DESCRIPTIVE REPORT

Field No. H11840 _____

General Locality _____ Northern Cook Inlet _____

DESCRIPTIVE REPORT
OPR-P358-TE-08

Figure 4 – Contours from H11840 (colored) overlaid on chart 16665

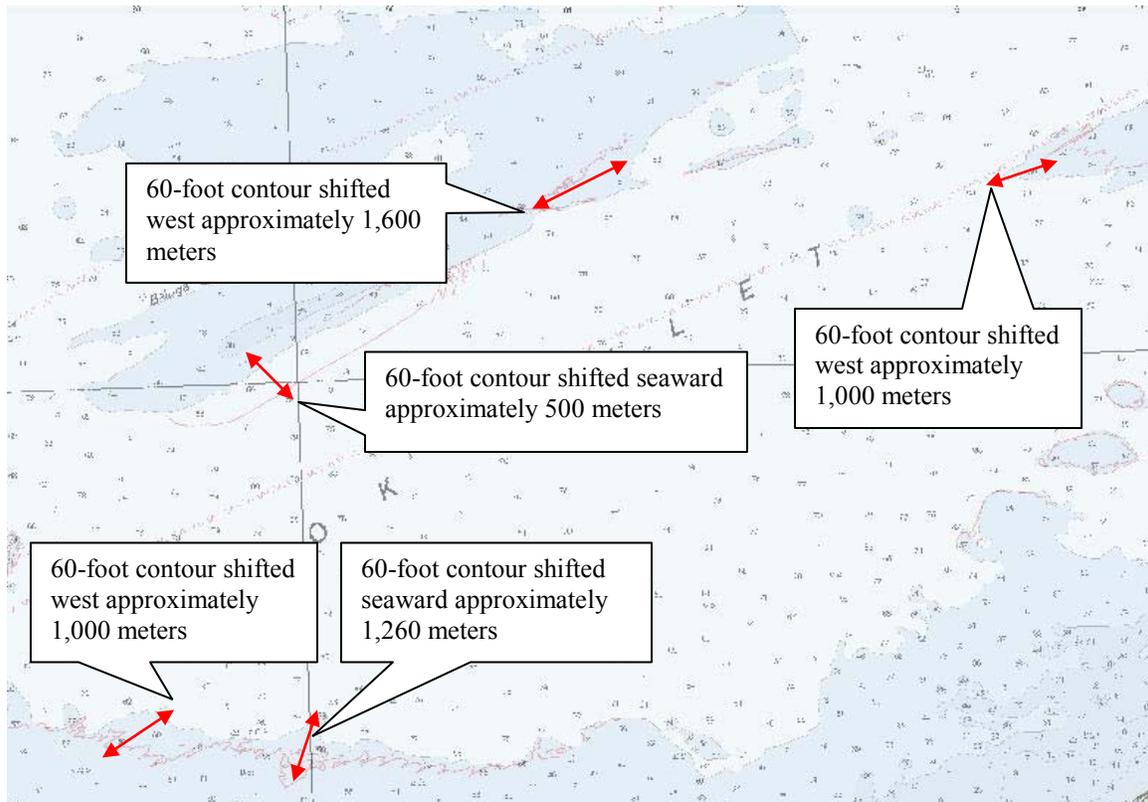
Several seaward and westward shifts of the 60-foot contour in the eastern portion of the survey area are illustrated below. *Concur*

The hydrographer recommends that the charted contours be updated to reflect the 2008 survey data. **Concur**

Figure 5– Contours from H11840 (colored) overlaid on chart 16663

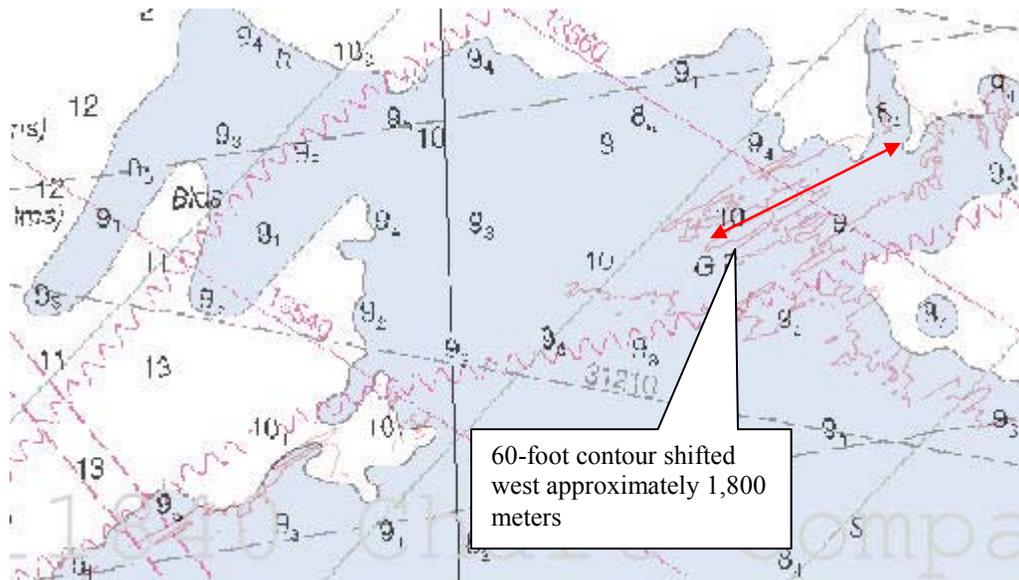
An example of 60-foot contour shift westward in the central portion, along the northern margin of the survey area, is illustrated below. *Concur*

1.1) GP No. - 1 from H11840_DtoN#01.xls**DANGER TO NAVIGATION****Survey Summary**

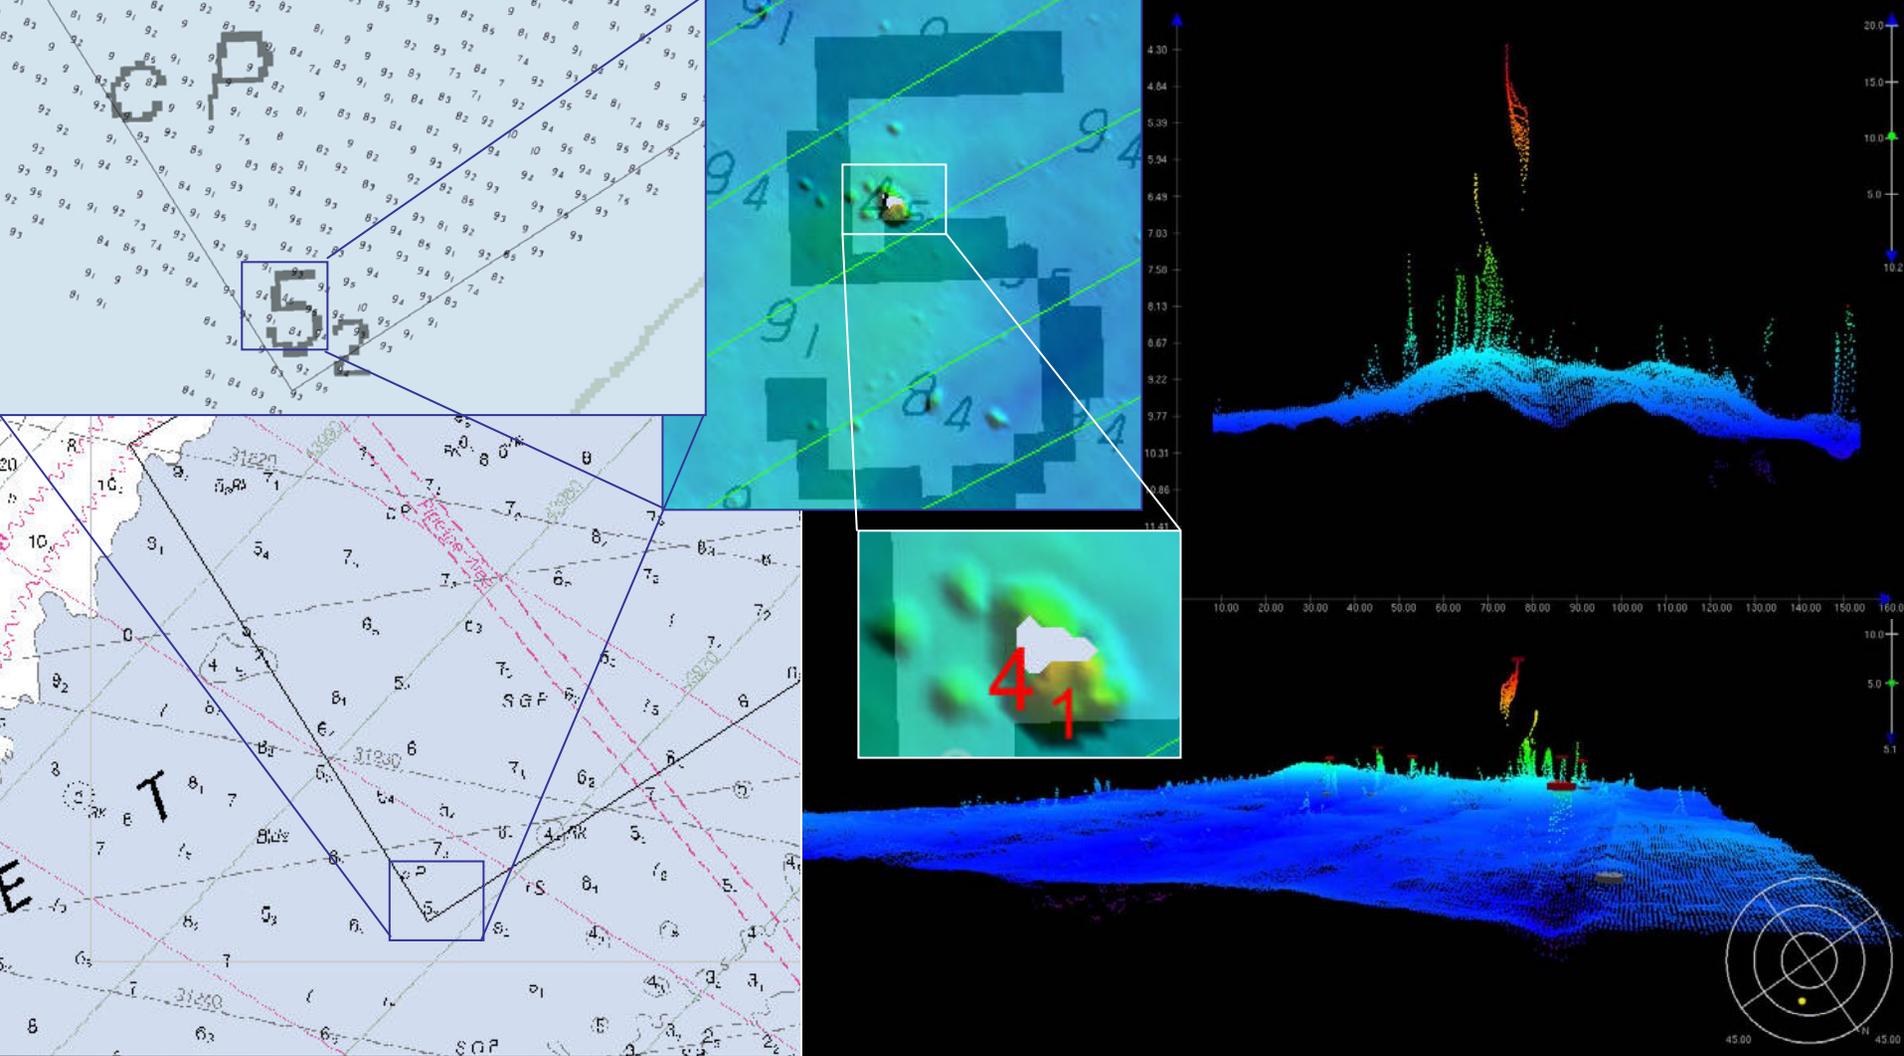
Rock with 4 fathoms 1 foot least depth in charted 5 fathoms 2 feet.

Recommend charting 4 fathoms Rock at current survey location.

Concur with clarification. Shown on chart 16663; 8th Ed., and smaller scale charts as a dangerous rock, least depth 4 fathoms 1 foot. Office processing determined that the position and least depth are different from the initial DToN submission to MCD. Delete charted dangerous rock, least depth 25 feet. Chart dangerous rock, least depth 4 fathoms 1 foot, at the present survey position in Latitude 60°57' 53.3628" N, Longitude 150° 51'06.4512" W.

2. Processing Workflow Flowchart Technical Note

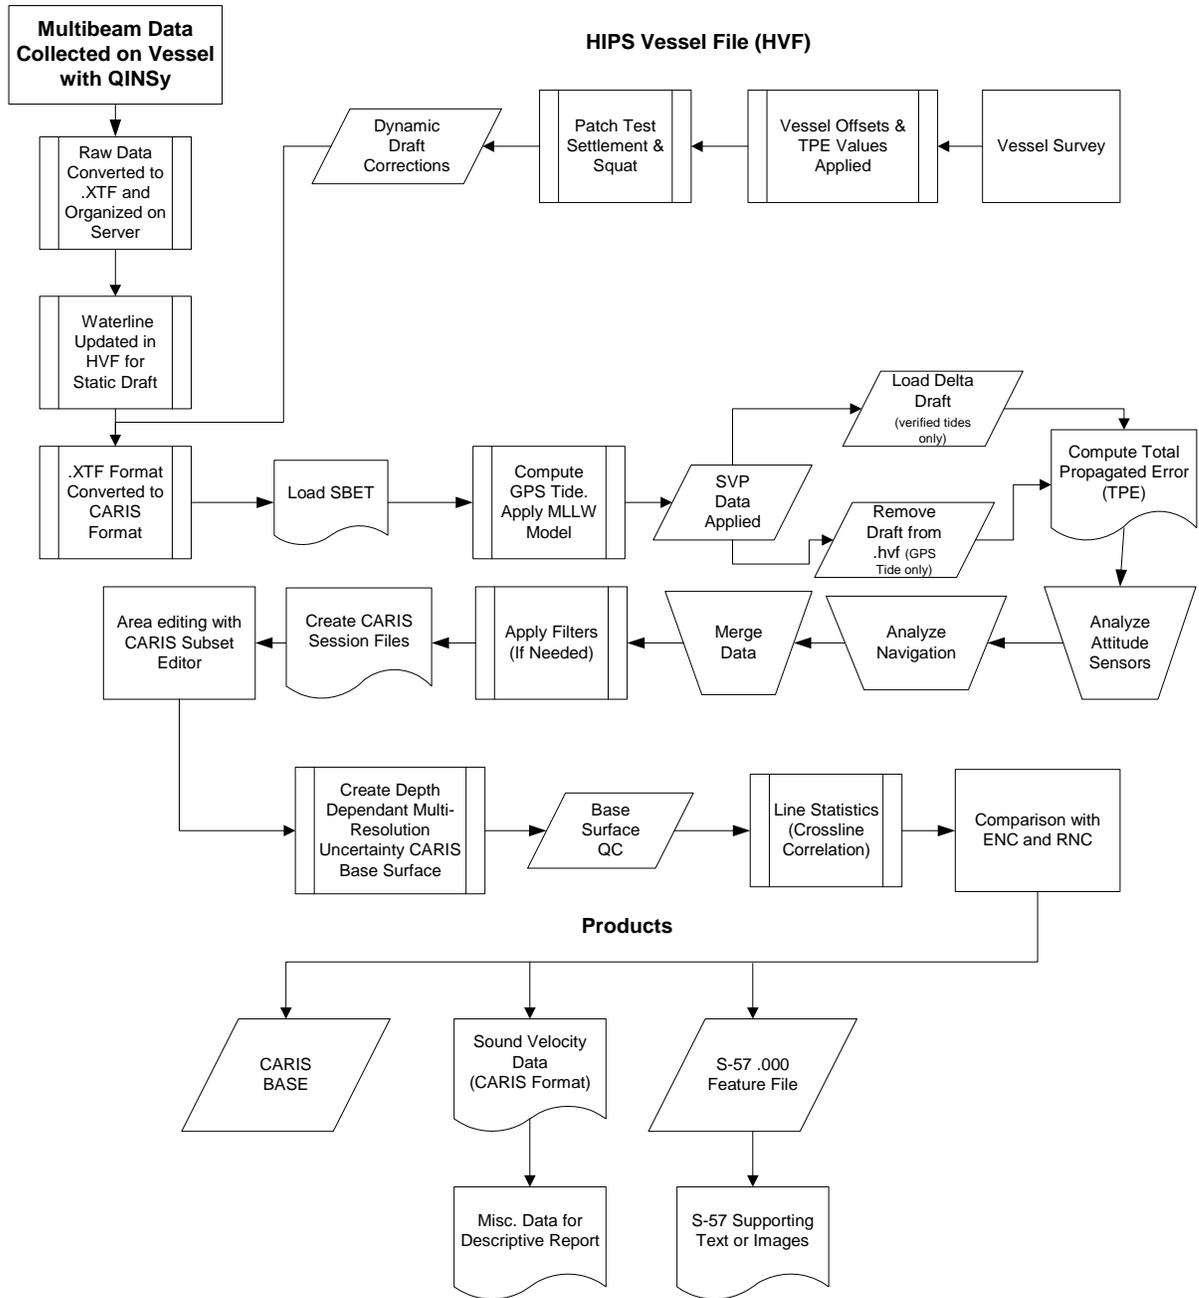
DAPR Section B.6 Field Data Processing (pg. 20) data acquisition and reduction flowchart needs to be amended to reflect the removal of speed-based dynamic draft values from the vessel file associated with survey lines processed with PPK-based GPS tide and the loading of rpm-based delta draft values for those lines processed with verified tides and zones.

The following diagram should replace *DAPR Section B.6 Field Data Processing (pg. 20)*:
